Peer Review of Flood Assessment for Club Punchbowl Planning Proposal

Prepared for Canterbury Bankstown Council

Reference no. 300204010 | 18 March 2024

Figure 4-10 Peak Flood Levels and Flood Depths in the 1% AEP Post-Development Scenario

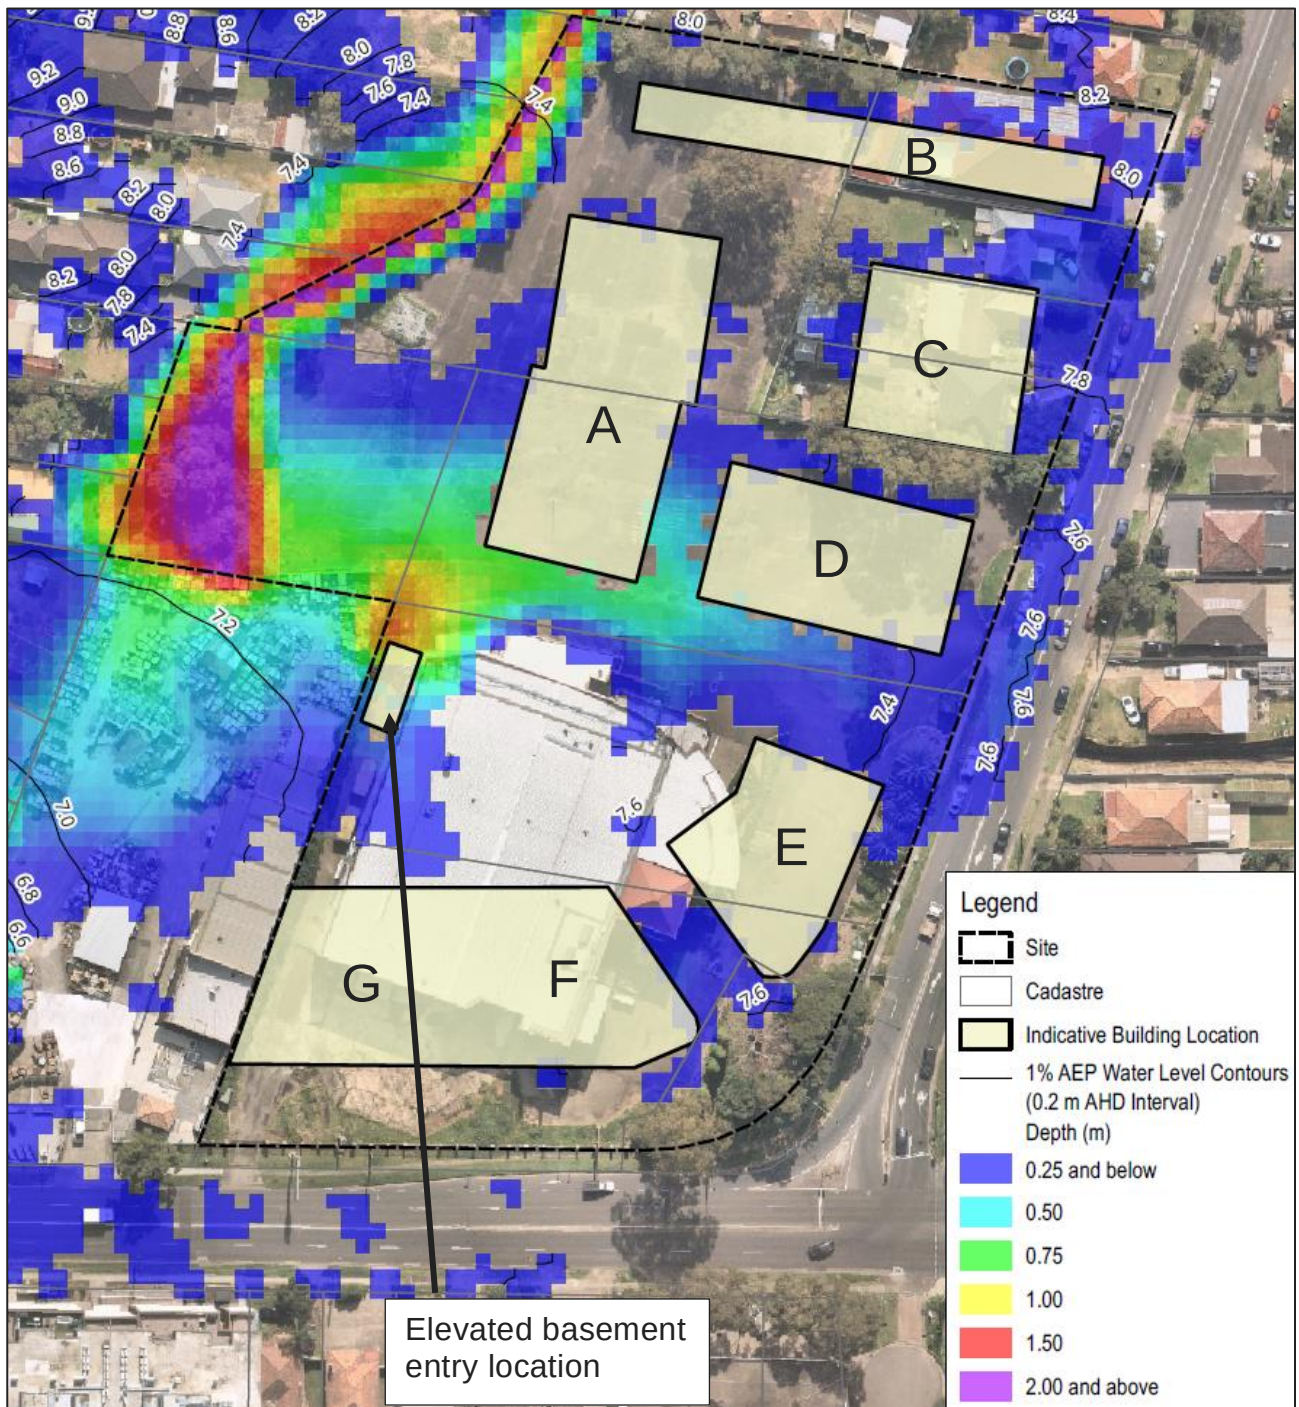
The peak 1% AEP flood levels in the form of 0.2 metre contours are included in **Figure 4-10** (extracted from Ref 10). The PMF flood levels in the site are shown in **Figure 4-11** (extracted from Ref 4).

Referring to Schedule 5 of Chapter 2.2 of Canterbury-Bankstown DCP 2023, a 0.5m freeboard is applicable to both residential and commercial habitable floor levels. Therefore with a 0.5m freeboard to the 1% AEP the Flood Planning Level for:

- > Central buildings A1, A2, and D would have a FPL around 7.8 – 7.9m AHD (the 1% AEP flood levels are between 7.3 – 7.4m AHD), compared to PMF levels between 7.7 – 8.0m AHD.
- > The furthest north, building B would have a Flood Planning Level of between 8.5 – 8.6m AHD (1% AEP level is 8.0 – 8.1m AHD), compared to PMF levels of 8.2m AHD.
- > Northern building C, Flood Planning Level would be around 8.3 – 8.4m AHD (1% AEP level around 7.8 – 7.9m AHD), compared to PMF levels of 7.9 – 8.0m AHD.
- > Southern commercial buildings E, F, and G would have a Flood Planning Level around 8.1m AHD (1% AEP level around 7.6m AHD), compared to PMF levels of 7.6 – 7.8m AHD.

These flood planning levels are only indicative, with further detailed modelling required to confirm FPL requirements as part of a future DA stage submission for the development.

Figure 4-11 Peak Flood Levels and Flood Depths in the PMF Post-Development Scenario

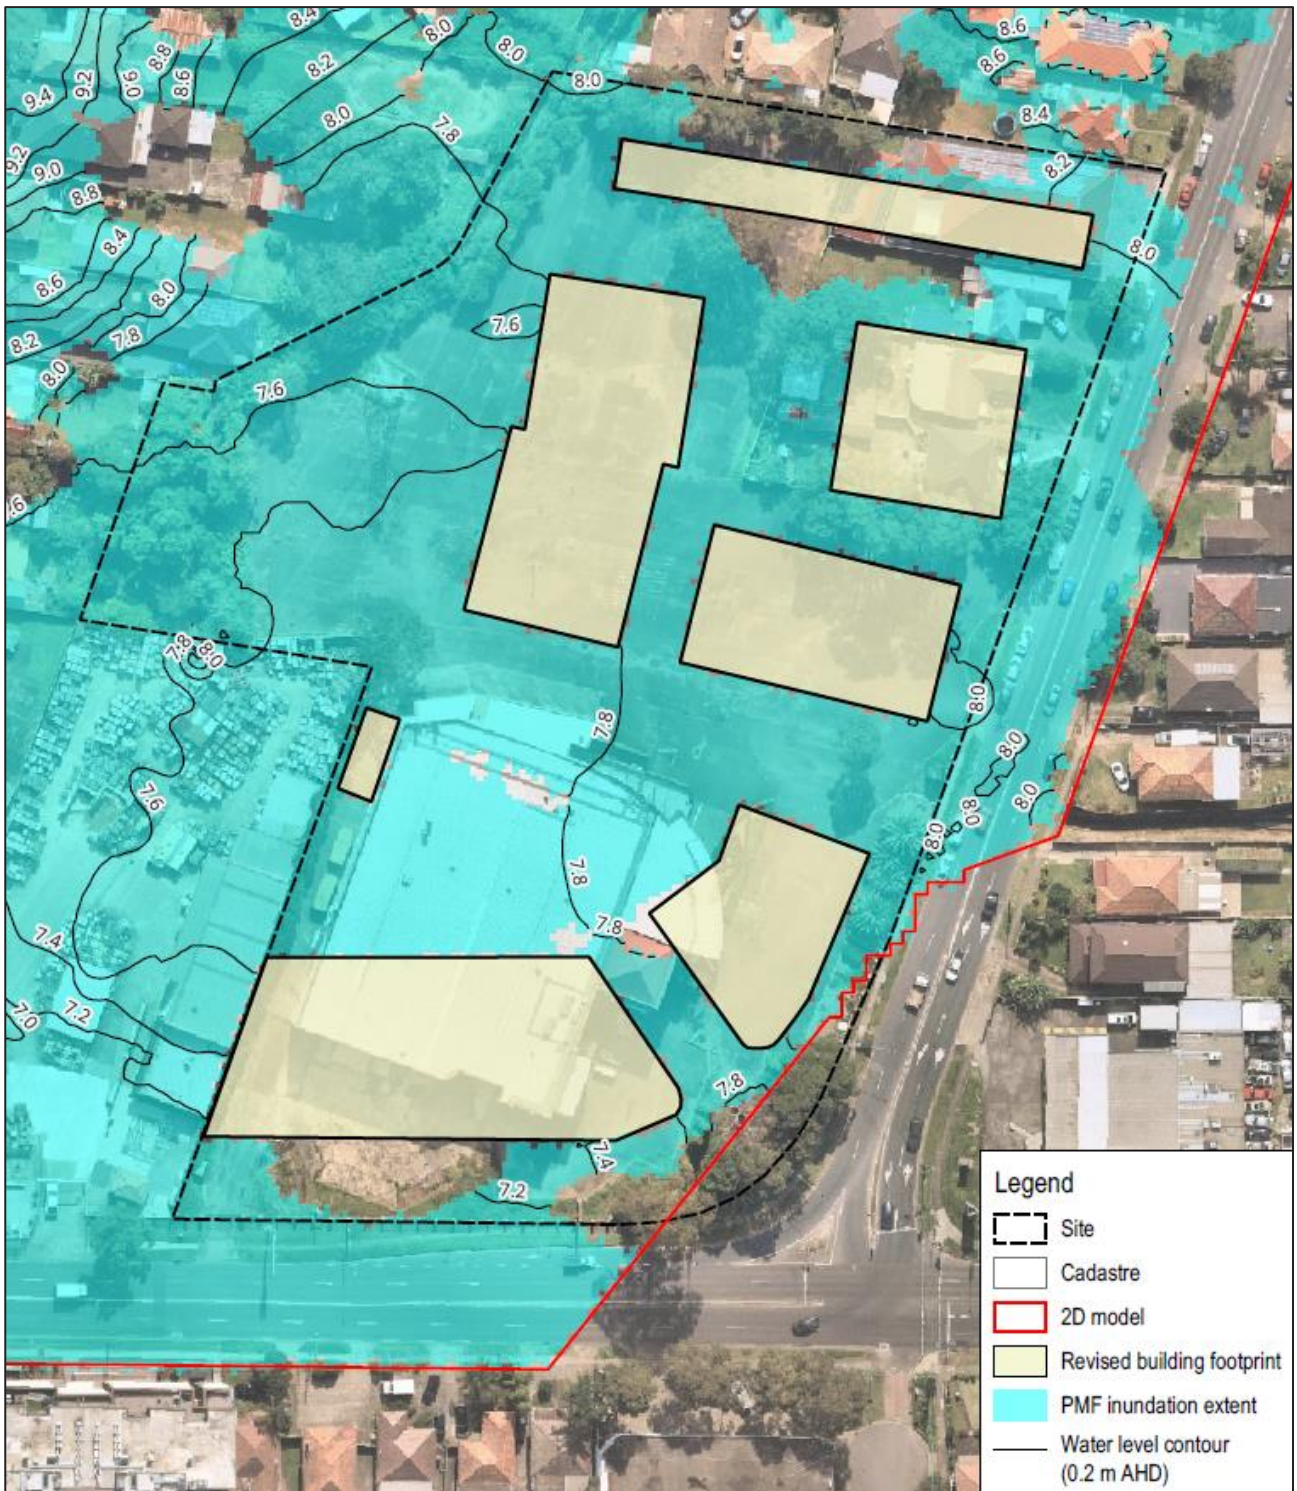
In this regard, the post-development PMF flood level across the site is generally less than RL 8.0 m AHD. Subsequently, all floor levels proposed at or above RL 8.0 m AHD will be located above PMF floodwaters, removing the need for vertical evacuation. This advice will be included in the planning report.

As noted above, at most locations the FPL (1% AEP plus 0.5 metre) is similar to the PMF level for the site. Therefore as part of later development stages including architectural design of the buildings, by meeting FPL requirements in the future, the building ground levels would likely be elevated above the PMF level. Hydracor's proposal to elevate ground floors above the PMF level would simplify the flood emergency response planning for the site. Therefore applying a design of ground floor levels at or above the FPL or PMF, whichever is greater is a suitable approach.
